Date: July 9, 02
 To: T10 Technical Committee
 From: Jim Coomes (jim.comes@seagate.com)
 Subject: SAS bit and byte order for scrambling, CRC and transmission

Figure 1 – Link layer receive path

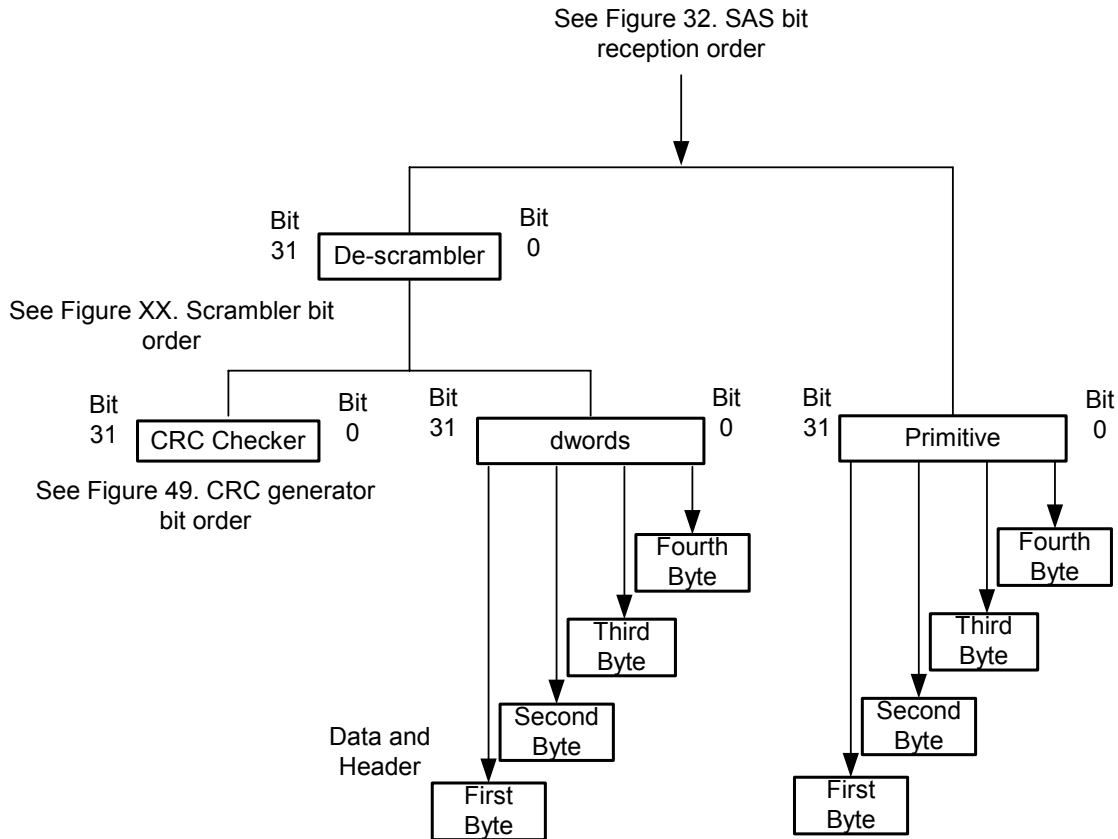
Rev 3 includes changes from the SAS Protocol conference call July 9, 02. The spelling of byte was corrected and the figure titles were changes for "port" to "link layer".

This update includes figures illustrating the byte and bit order for SAS transmit and receive paths. If adopted, the current scrambling, CRC, transmit order and receive order bit order figures in the SAS draft remain unchanged.
